Re: Railway (Metrolink - Estuary to Charlemont via Dublin Airport) Order [2022]
Metrolink. Estuary through Swords, Dublin Airport, Ballymun, Glasnevin and City Centre to
Charlemont, Co. Dublin

RE: SUBMISSION ON THE METROLINK ON BEHALF OF EARLSFORT BASIN LTD, (PREVIOUSLY EARLSFORT VENTURES LTD) IN RELATION TO PROPERTY AT 15-18 EARLSFORT TERRACE, DUBLIN 2

Project Title	Project Metrolink – 15-18 Earlsfort Terrace, Dublin 2	From	Robert Coughlan, PUNCH Consulting Engineers
Project No	222261	To	An Bord Pleanála
Subject	Technical Submission to Railway (Metrolink–Estuary to Charlemont via Dublin Airport) Order 2022 at – 15-18 Earlsfort Terrace, Dublin 2	Cc	
Date	12-01-2023

Appendix E – Drawings Illustrating the Close Proximity of the Tunnel to the Existing Buildings.

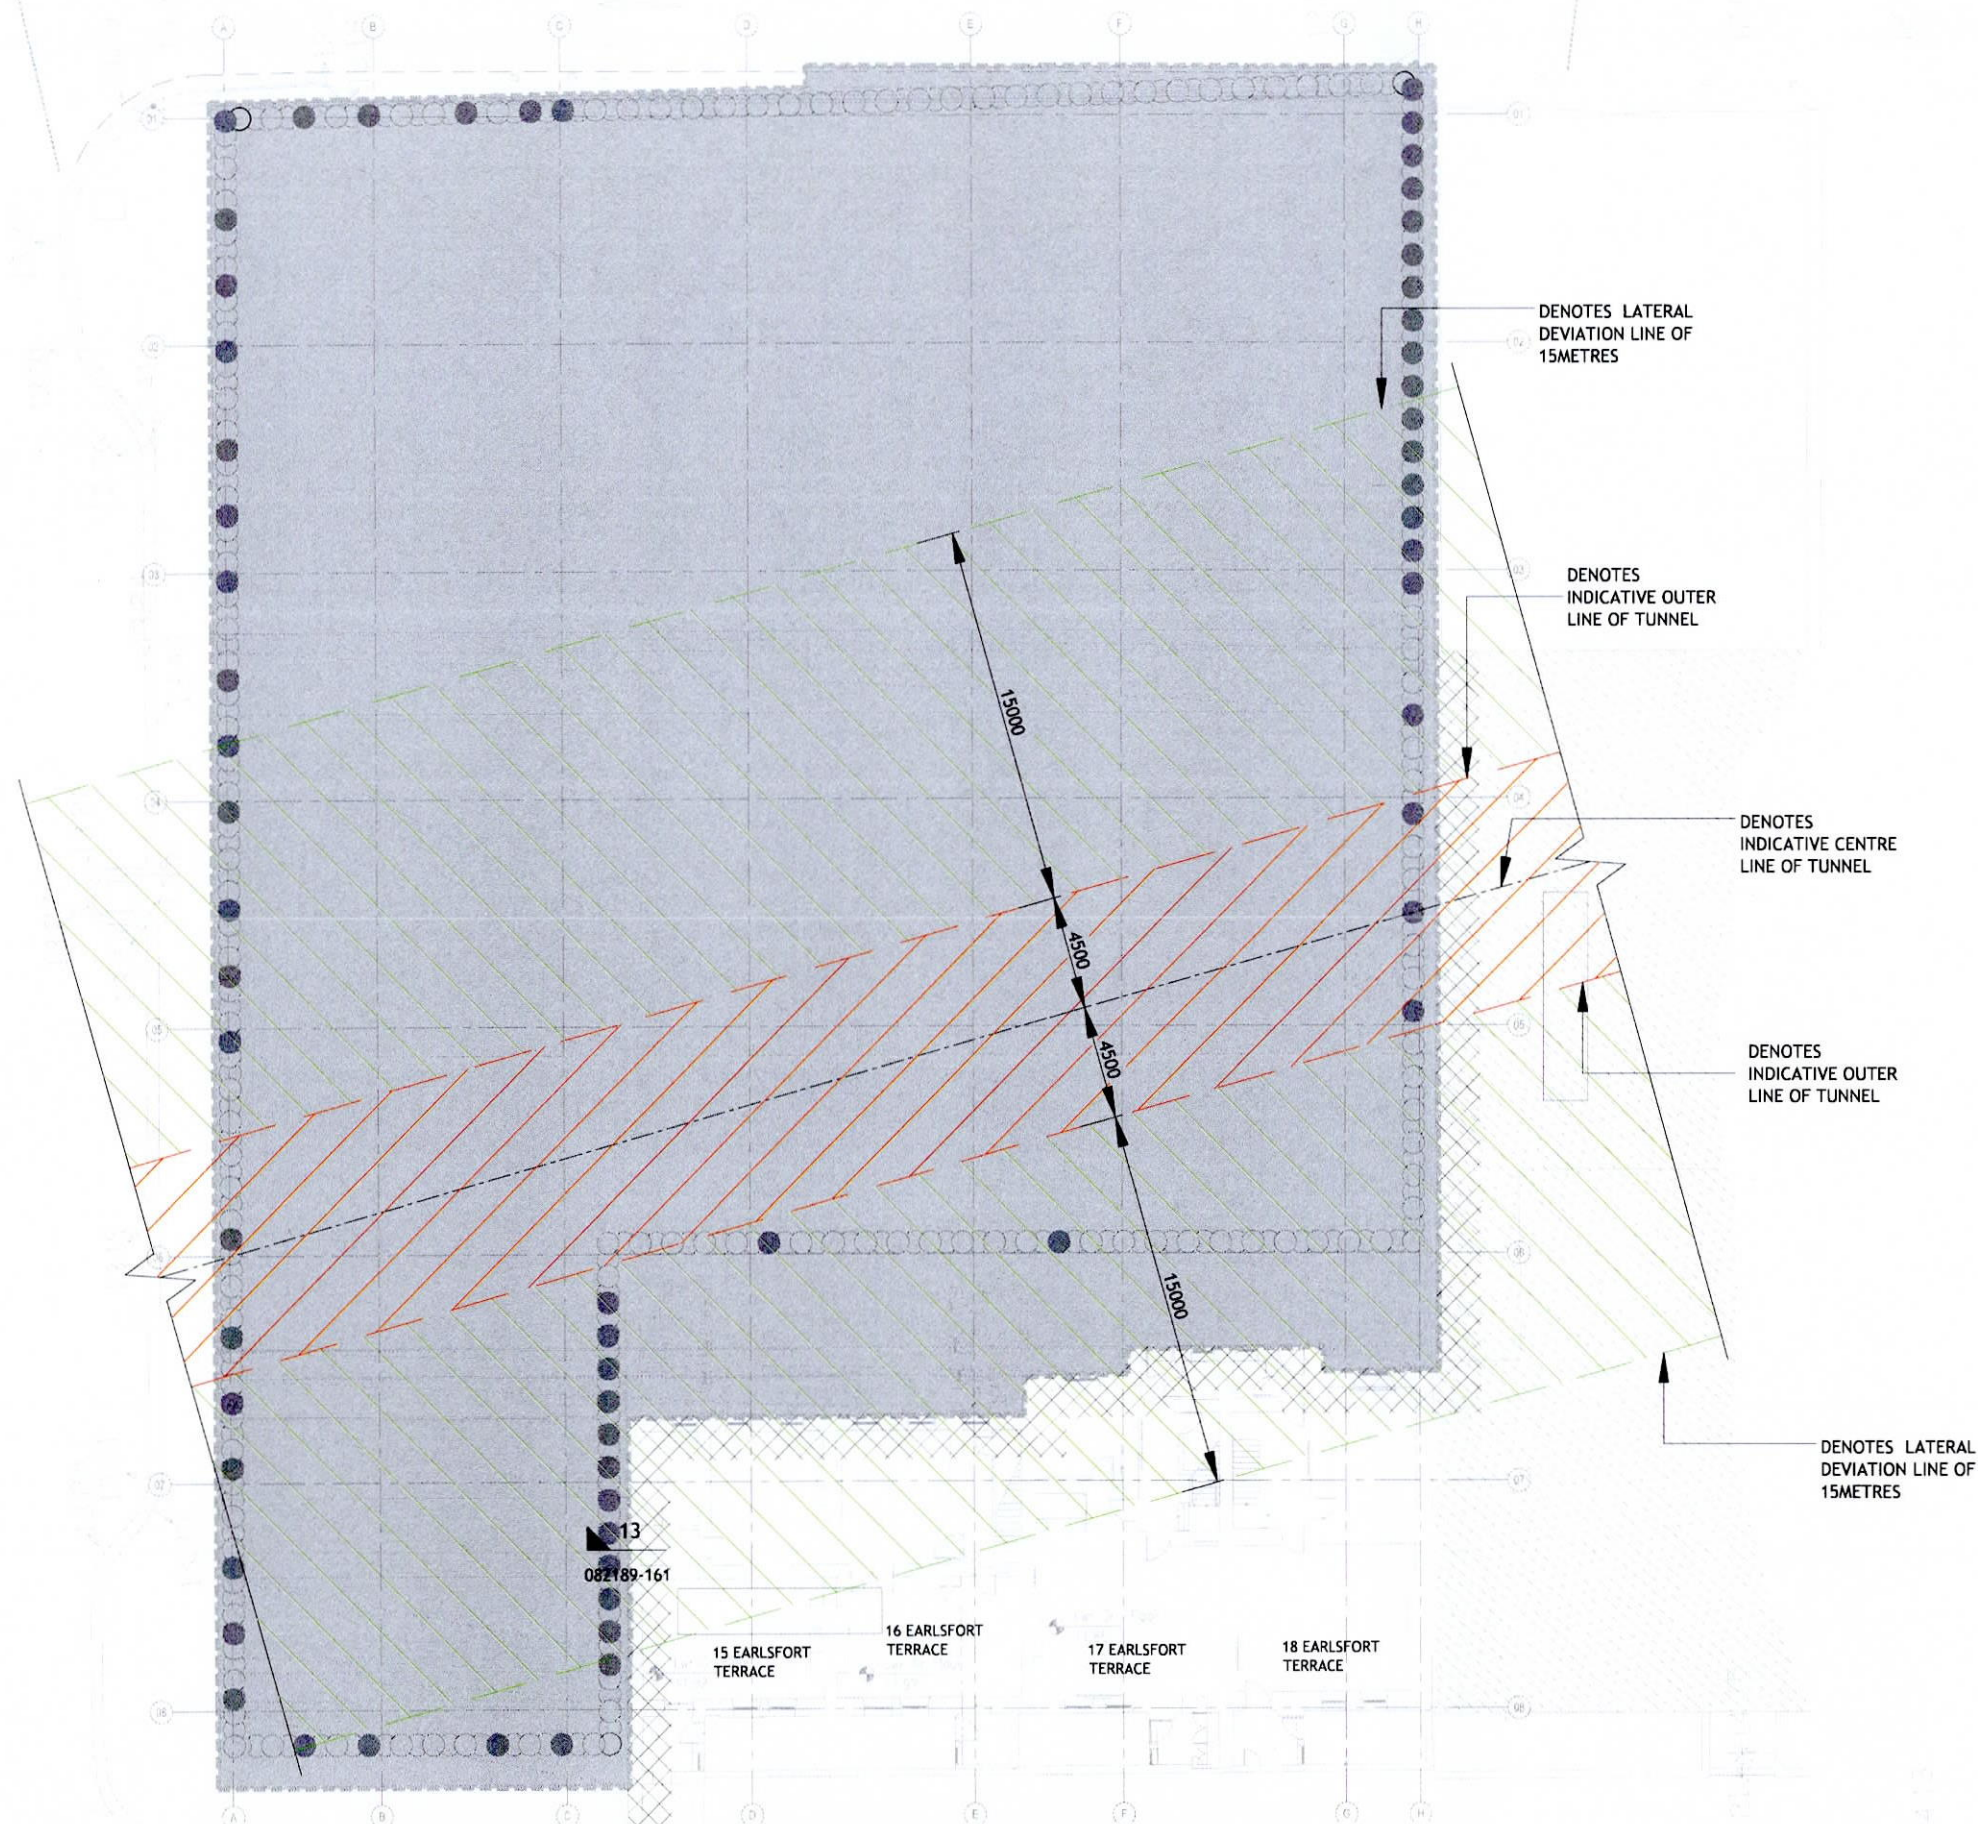
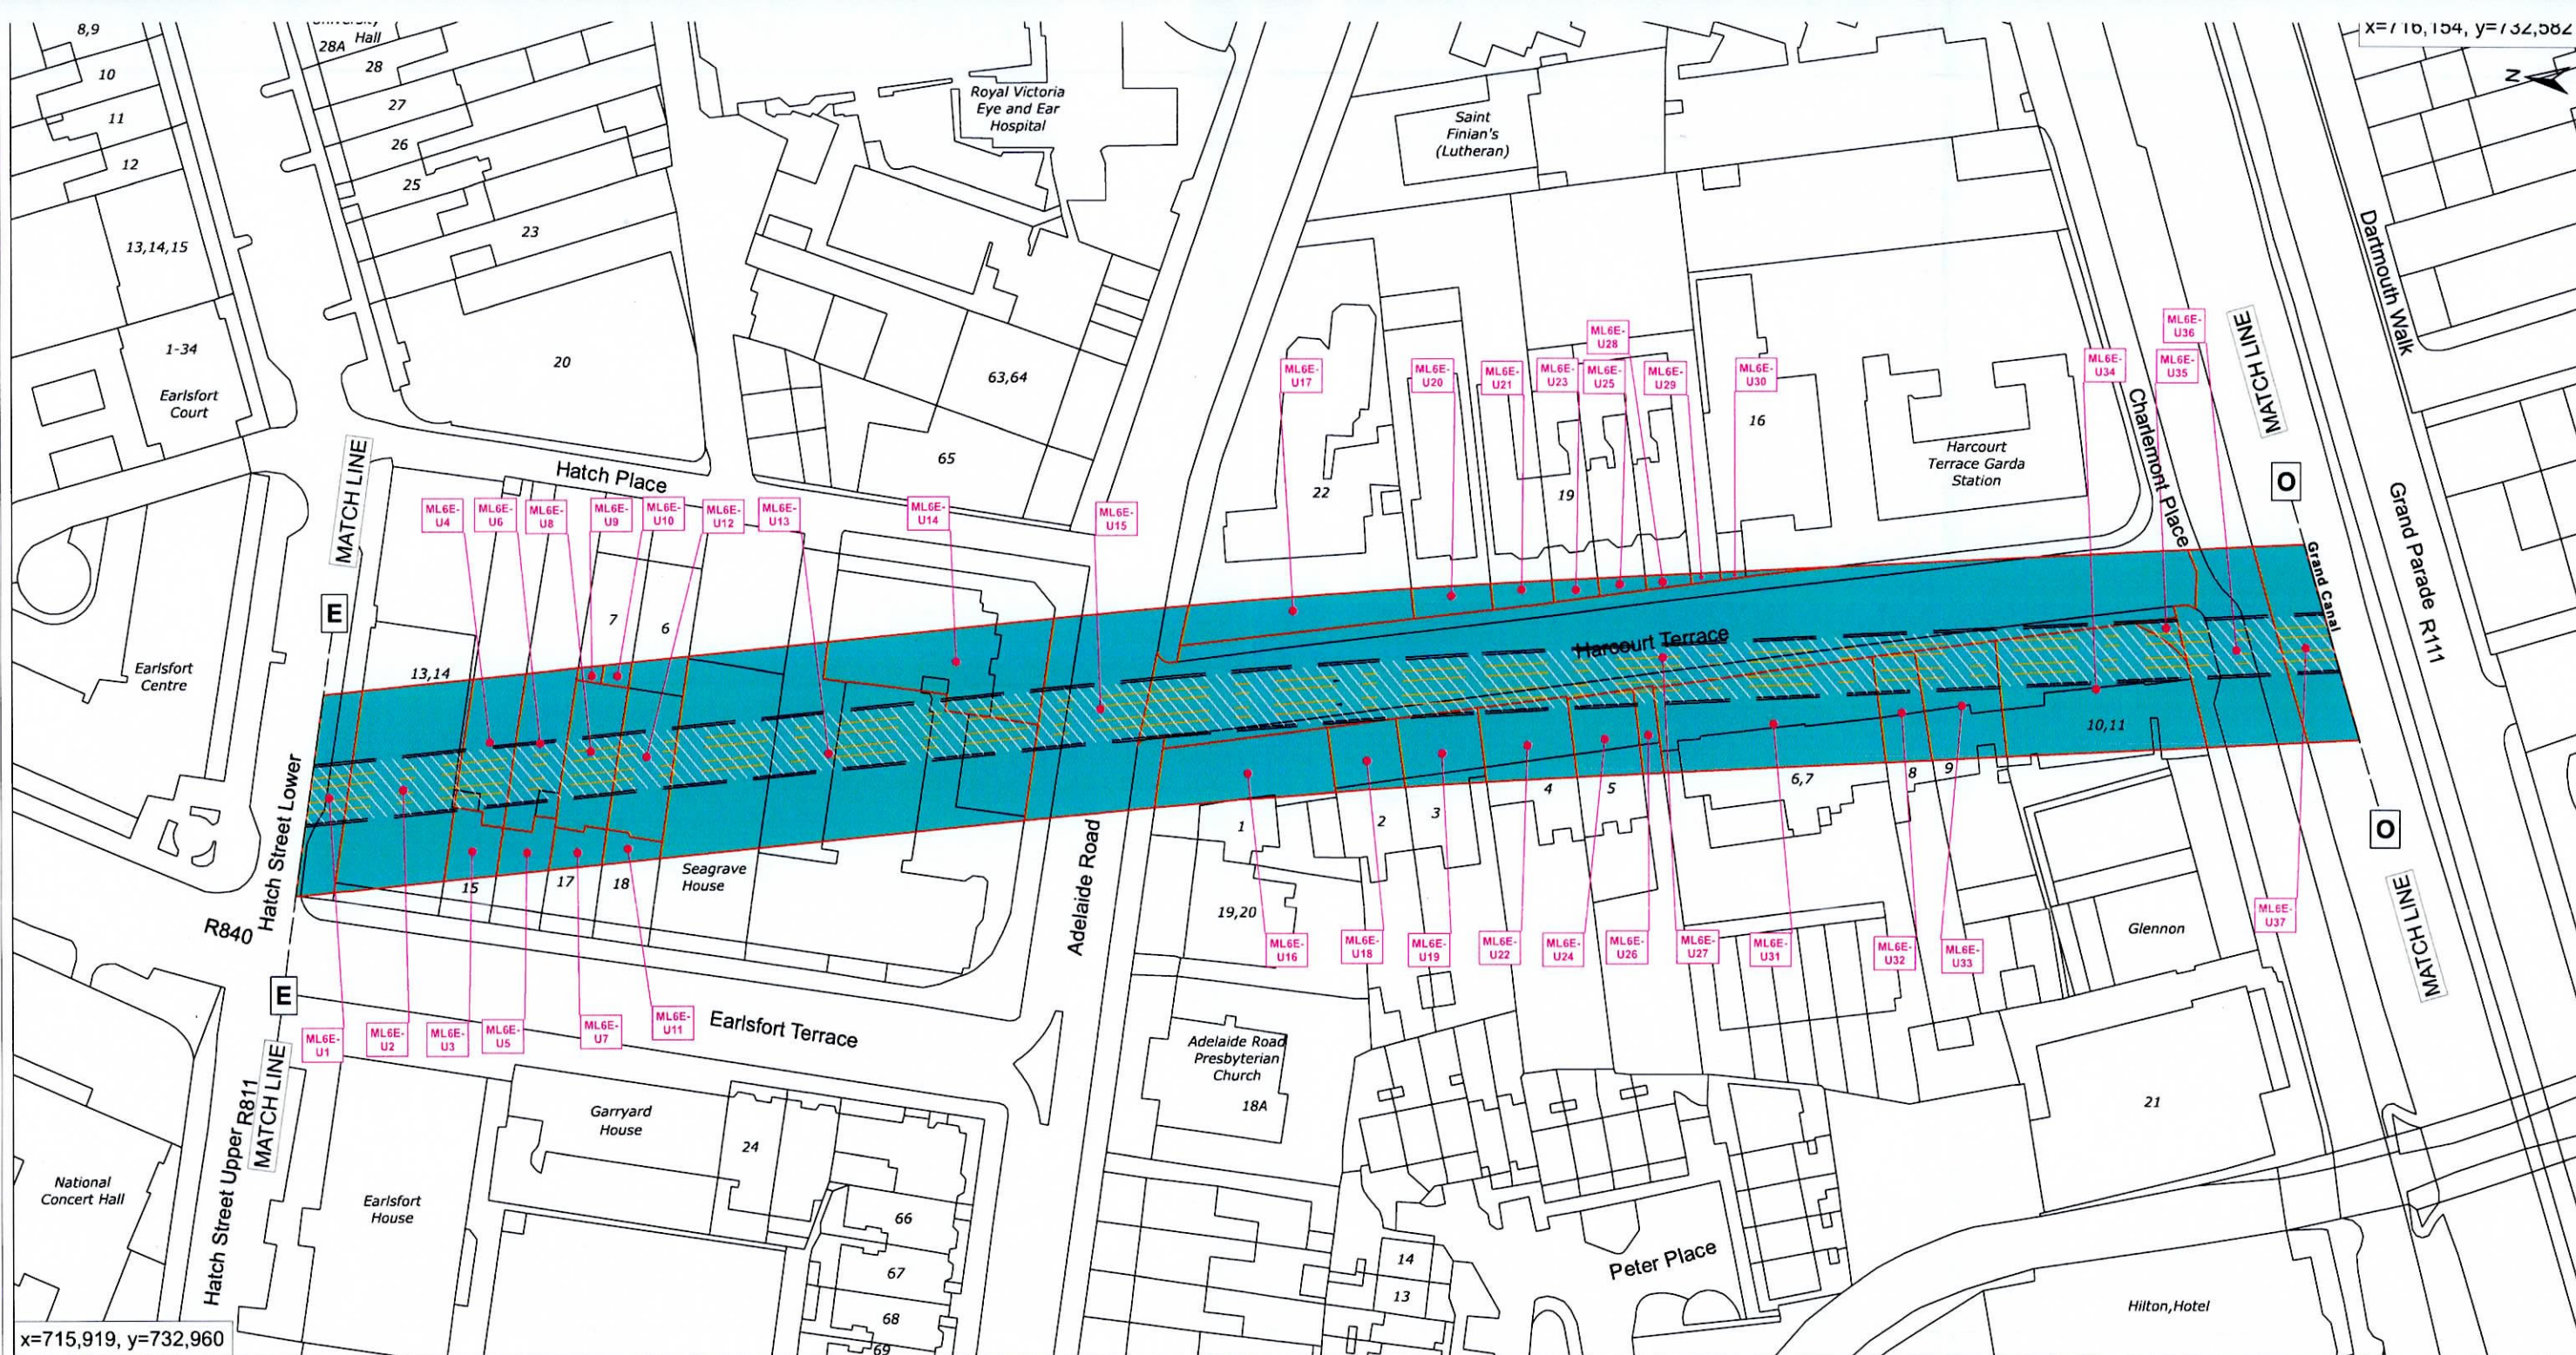
- i) We have concerns about the proposed tunnel location relative to the existing buildings at 15-18 Earlsfort Terrace both on plan and on section. . Refer Appendix E of this submission for drawings illustrating the close proximity of the tunnel to the existing buildings.
